Schenk-Atwood-Starkweather Creek-Yahara Neighborhood (SASY) Transportation Committee's Response to City of Madison

On October 8, 2014 Madison's City Traffic Engineering (TE) staff met with representatives of the SASY Transportation Committee (TC) and discussed issues related to traffic in the SASY Neighborhood.

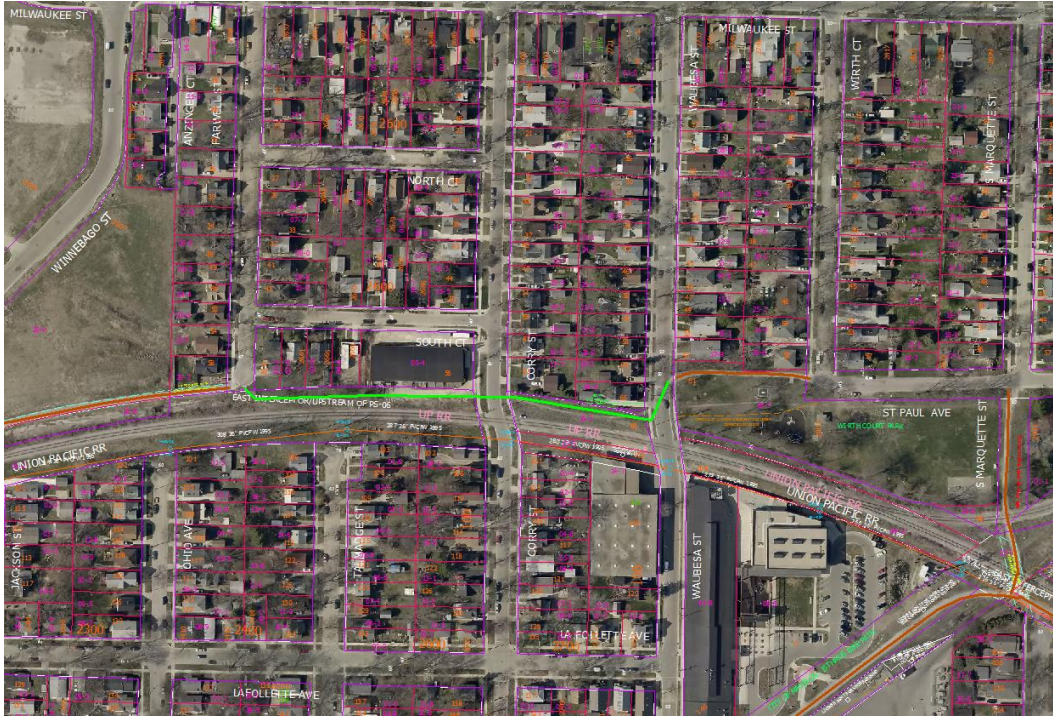
Neighborhood: Design and build an extension of the Wirth Ct. bike path, along the railroad track between Waubesa and the current "bike path to nowhere," which goes from the continuation of Division (north of LaFollette, former street, now bike path) east through the Union Corners land near the railroad track and ends at Farwell. The part of the path inside Union Corners was built before the recession, probably to conform to one of the proposed streets we expected to have been built seven or so years ago, and goes between what was Division and Farwell (see map). The bike path would need to be built between Waubesa and Farwell, crossing Corry and meeting up with the cul-de-sac with Farwell.

City TE: "Graphically this alignment generally looks like this:

This path connection makes sense; however, the path would have to be located in RR right of way. At this time we do not expect the RR would support the concept. The MPO will be including this path in their new bike plan, but construction is not anticipated anytime soon.”
